Location Address: 2005-2007-2011 Jackson Street, Hollywood, FL 33020

Explanation of Request: Applicant is proposing a new construction project for a multifamily use. It is a 7-story building, with 49 units in approximate 35,142 square footage of rentable area.

SUBJECT: Final Site Plan review for 49-Unit residential development (2005-2007-2011 Jackson)

A0-003

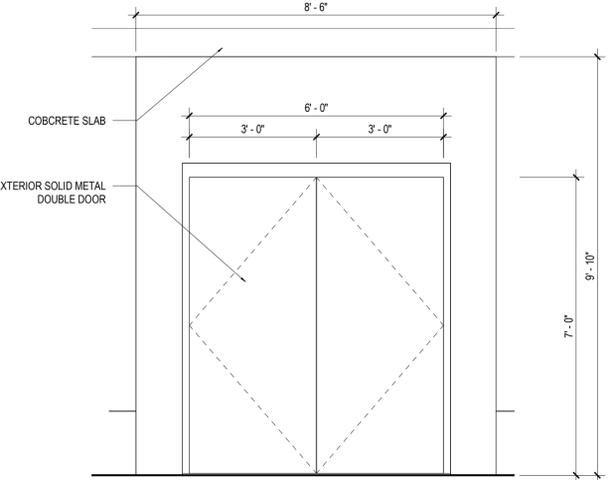
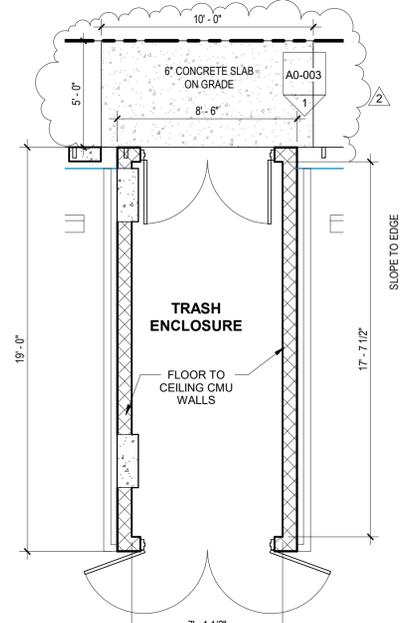
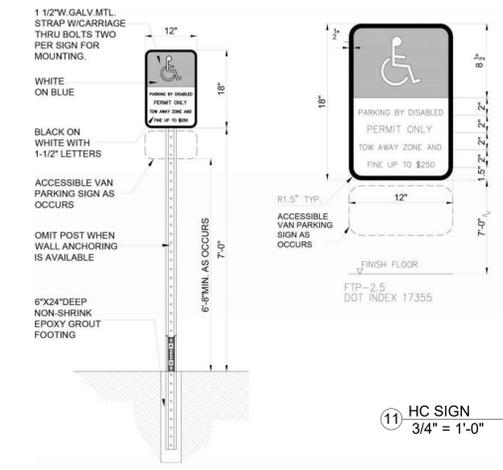
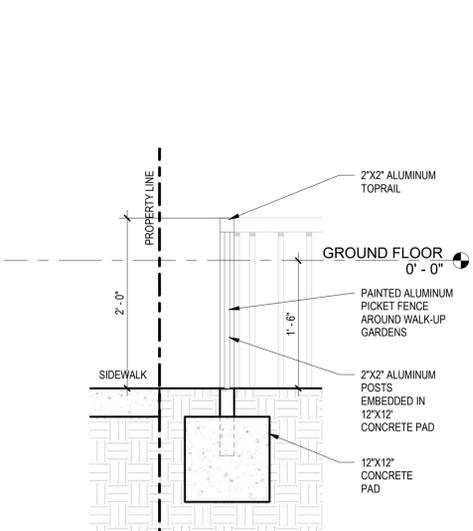
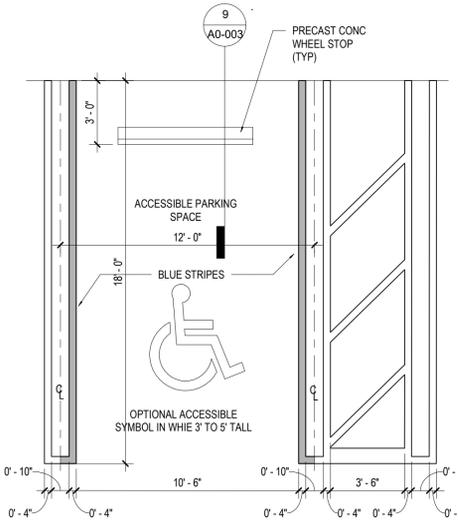
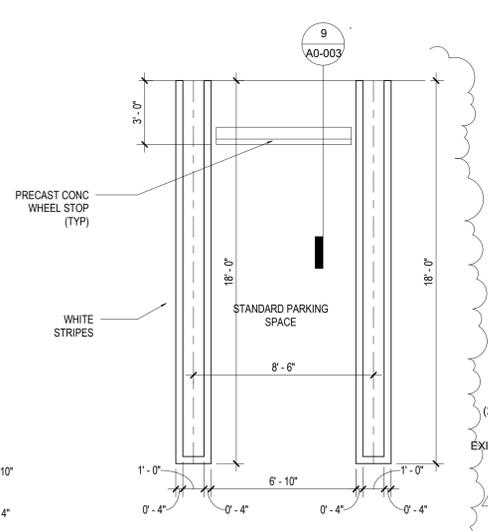
- 30) Sheet A0-001, in the Parking Analysis Table, 62 parking spaces are shown as provided, however, 61 is shown on plans.
- 31) Revise parking details on Sheet A0-003 to match Site Plan and all other plan sheets.

A1-100

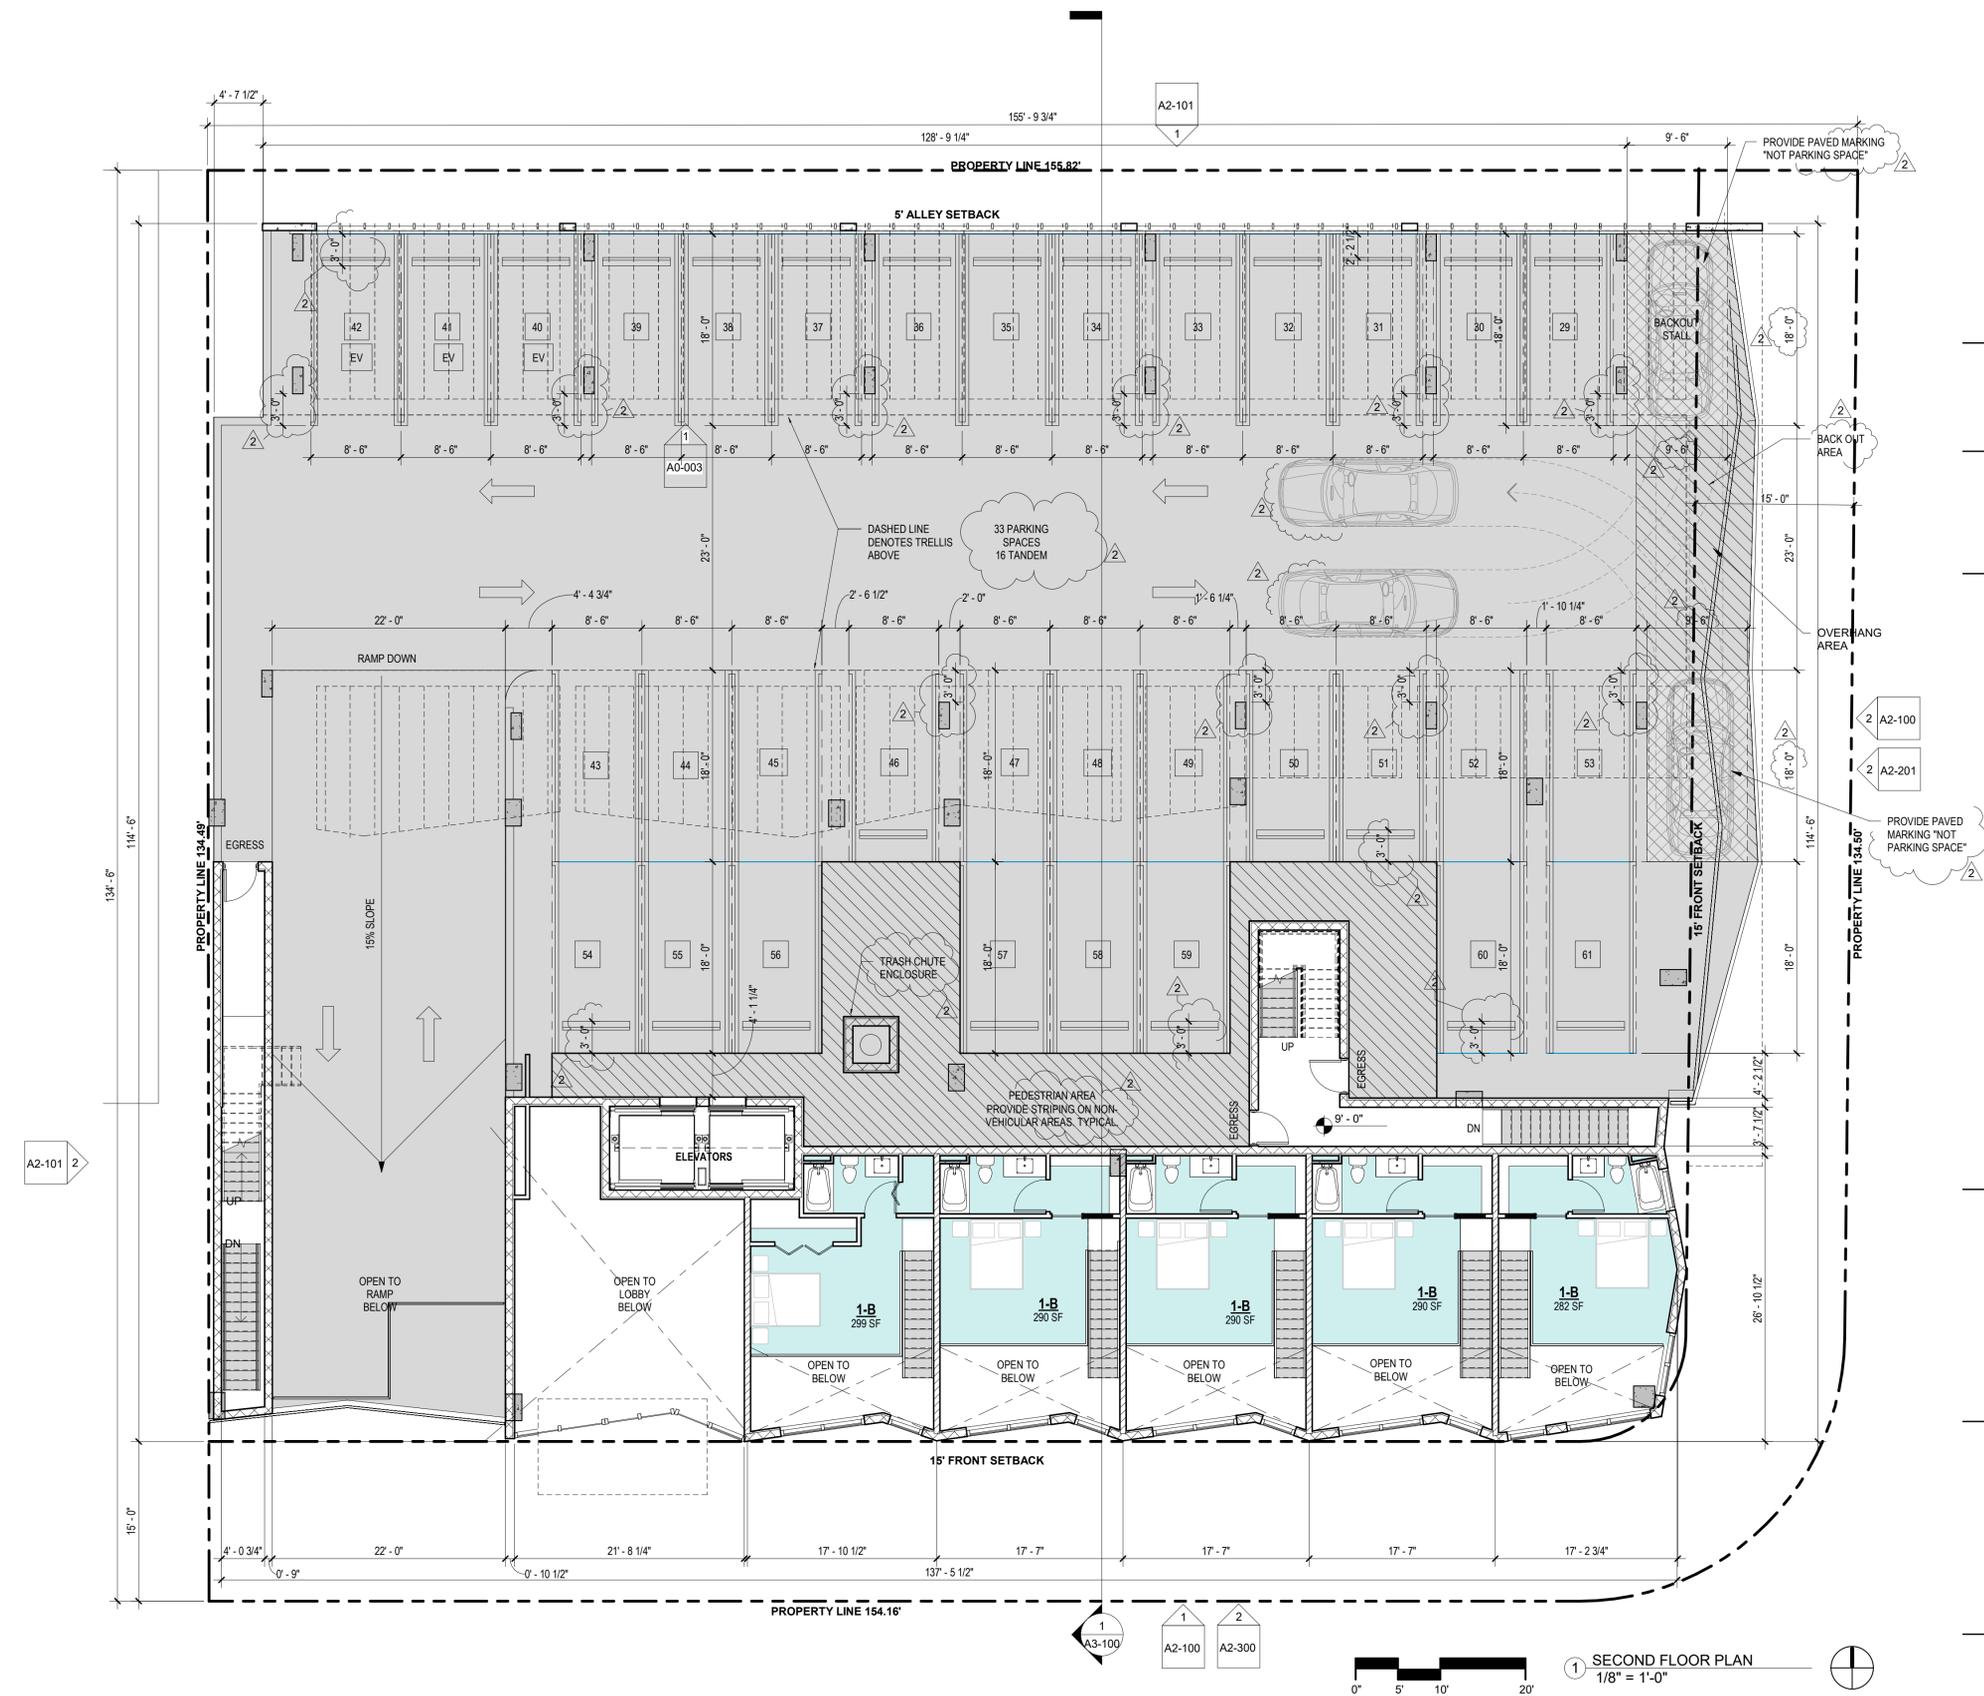
- 14) On Site Plan, fully show full rights-of-way of adjacent streets/roads and alley.
****Comment addressed.**
- 15) Sheet A1-100, please label square near the elevators, what appears to be the trash chute.

TYPICAL SECTION B-B
N.T.S.

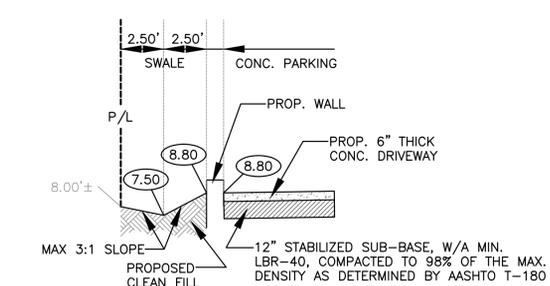
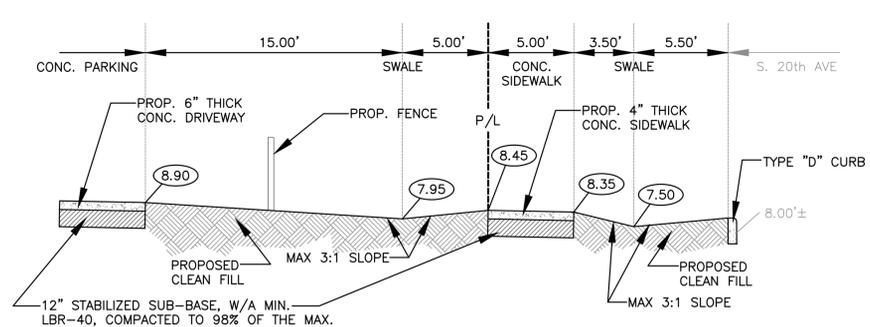
*****COMMENT PARTIALLY ADDRESSED. Section C-C should show Fence. Provide additional section across driveway.*****

Date 11/22/2022
 Scale 1"=10'-0"
 Drawn AM
 Check DV
 Sheet
LA1
 Of 2 Sheets

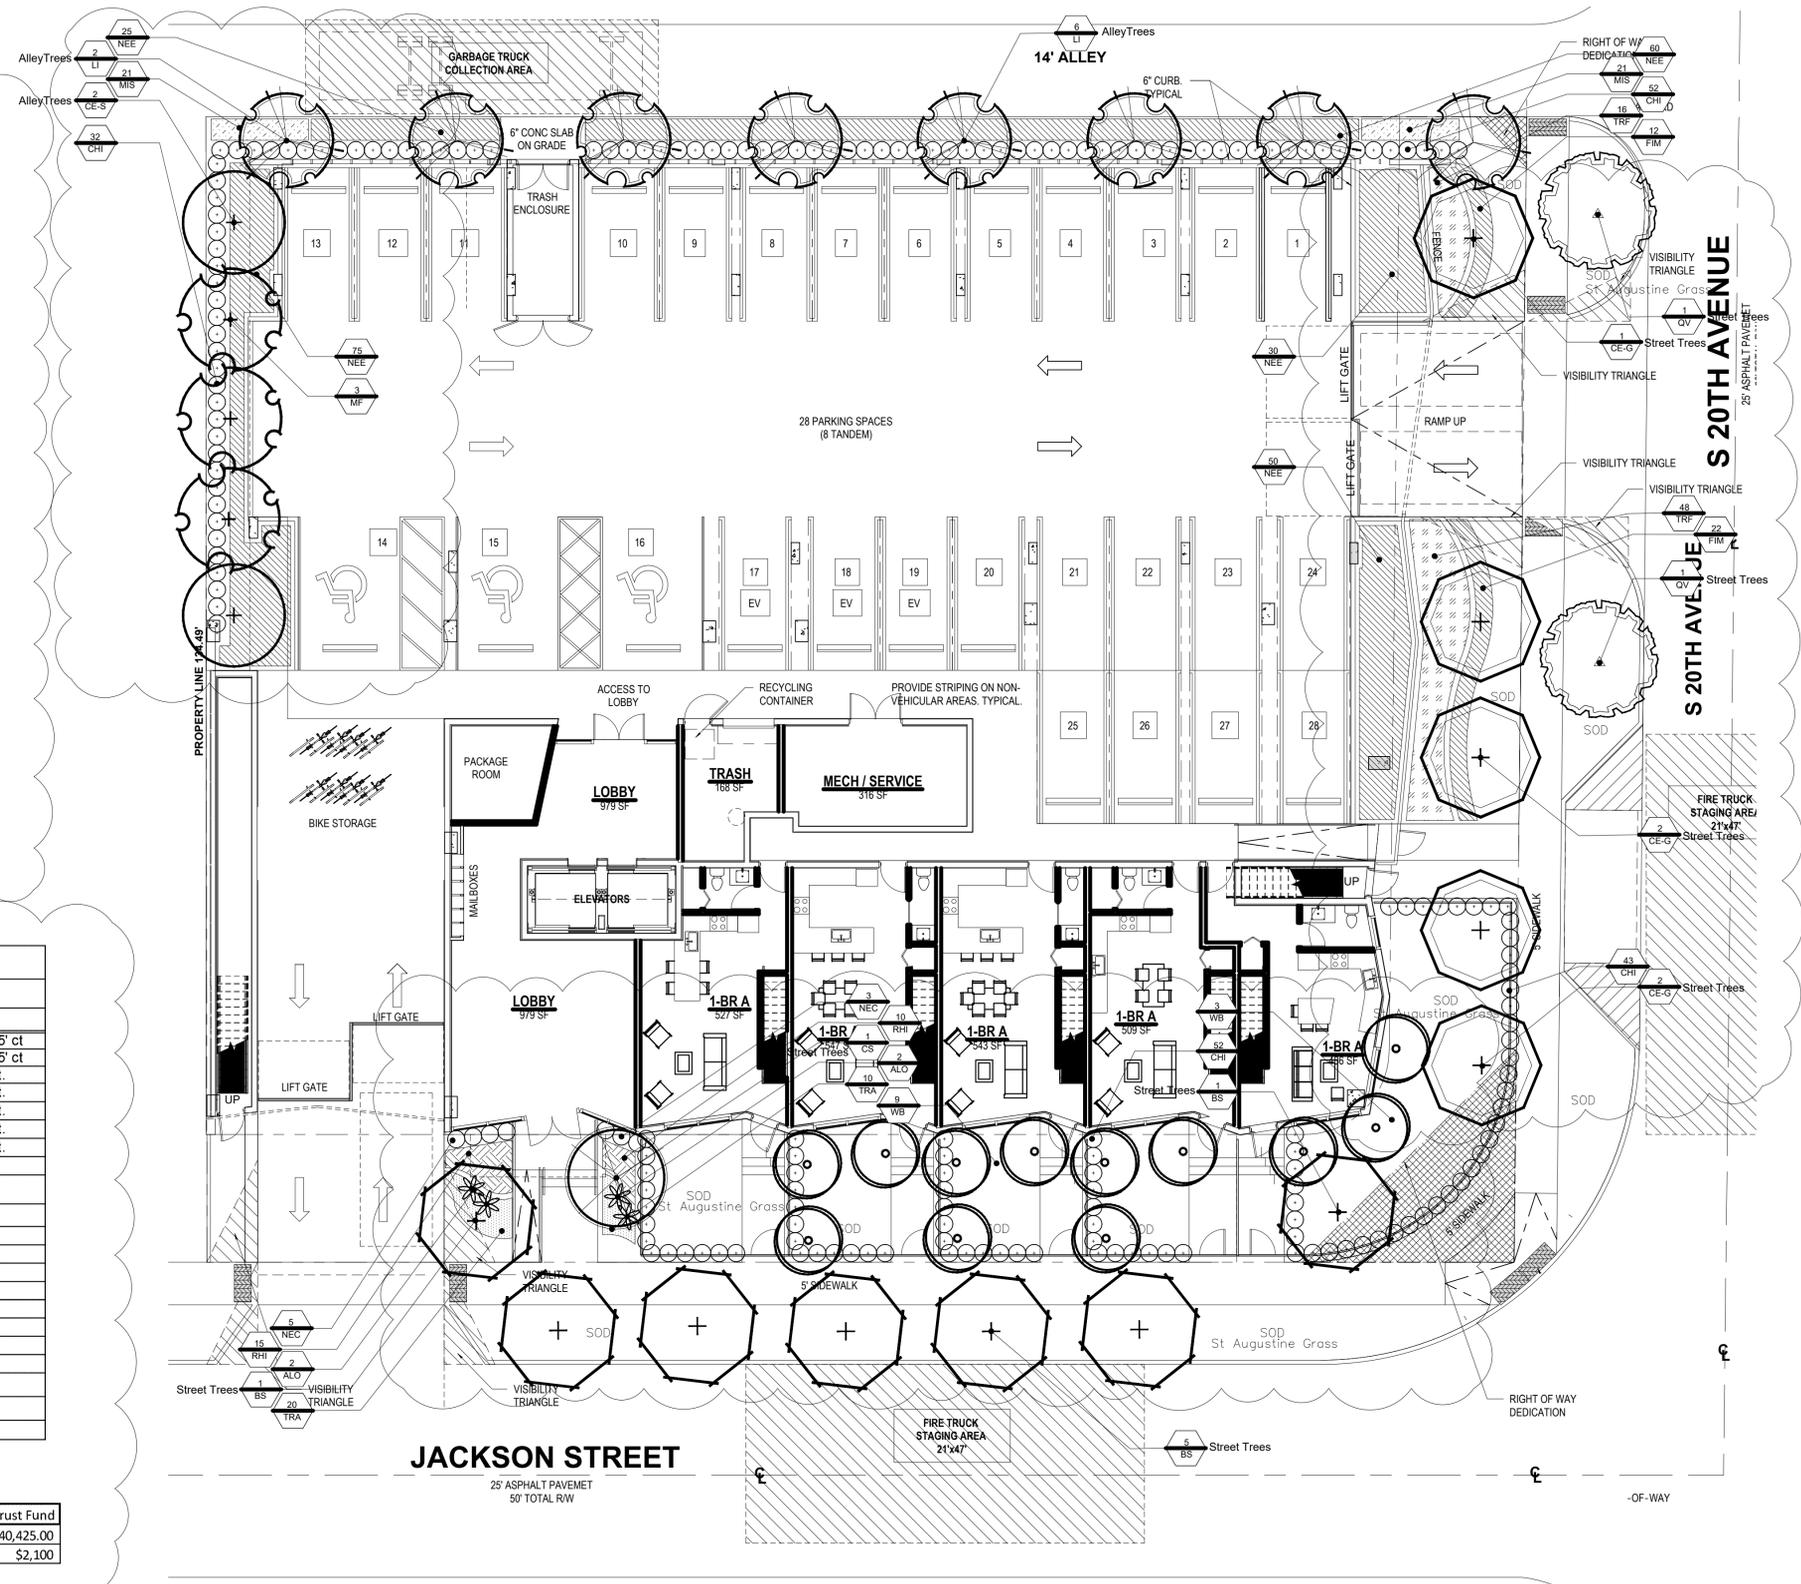
2. Revise legend with requirements to show the RAC zoning requirements: 1 street tree per 30 lf, 1 tree per 20 lf for landscape buffer within required setbacks, 1 tree per 20 lf when abutting an alley, 1 tree per parking island, 1 tree per 1,000 sf of pervious area of property.

-Provide alley/buffer requirements.

4. Add note: All landscaping shall be warranted for 1 year after final inspection.

5. Add note: Where required for screening purposes, hedge shall be planted at equipment height for visual screening.

6. Provide sod species on plant list and label on plan.

7. Site plan being used seems to be overlapping other lines. Revise site plan base for landscape plan. Label hatching inside garage and behind building.

Date 1/24/2022
 Scale 1"=10'-0"
 Drawn AS
 Check DV
 Sheet TD2
 Of 2 Sheets

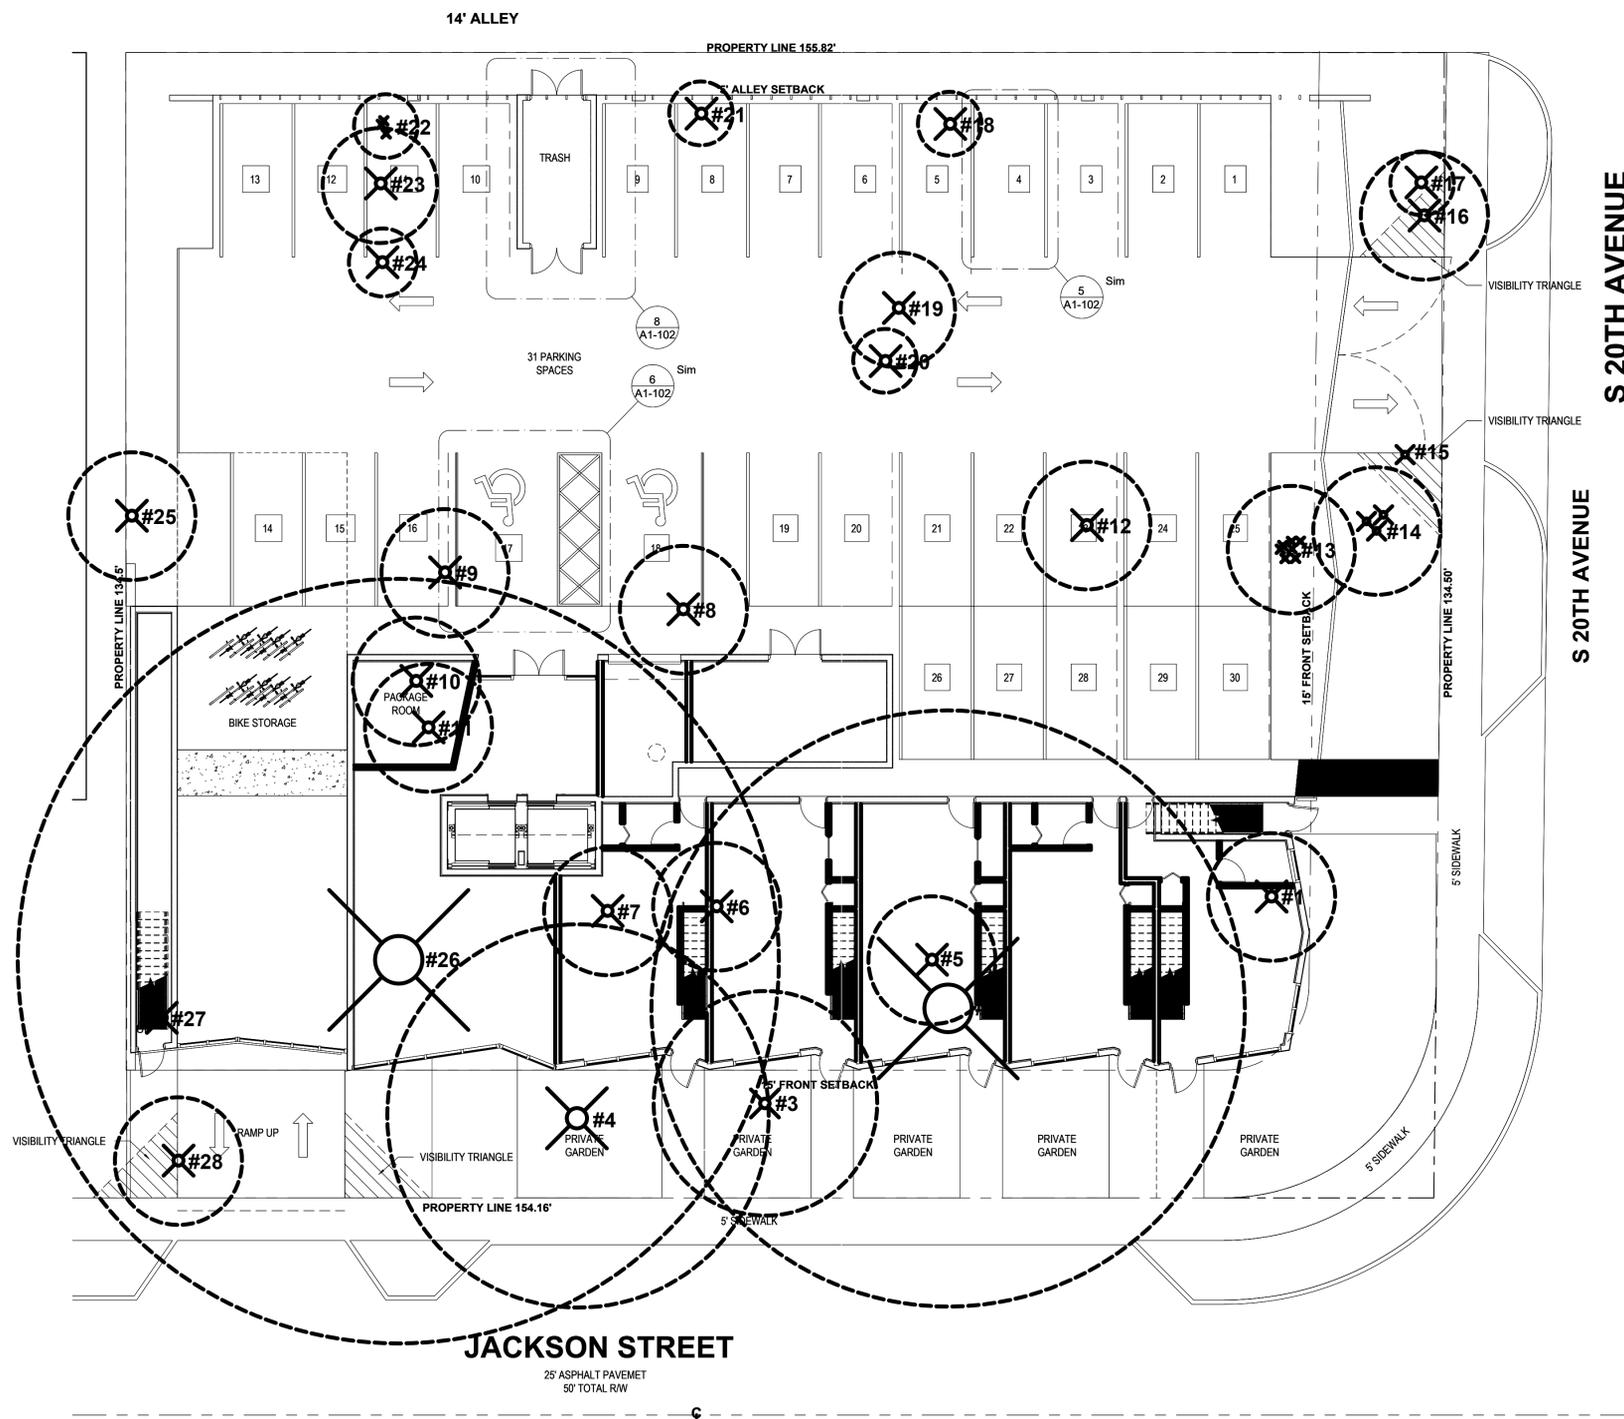
8. Provide chart on sheet TD-2 and show how the mitigation will be provided. Palm mitigation is 1:1. The following palm species should be used for mitigation or code: Royal Palm, Phoenix sylvestris/Medjool/canariensis, Bismarkia, Foxtail palm and Coconut palm. Minimum height requirements for all palms at planting is 8' of CT. Tree mitigation is inch per inch with a 12' ht, 2" dbh mitigation tree from the approved city list.
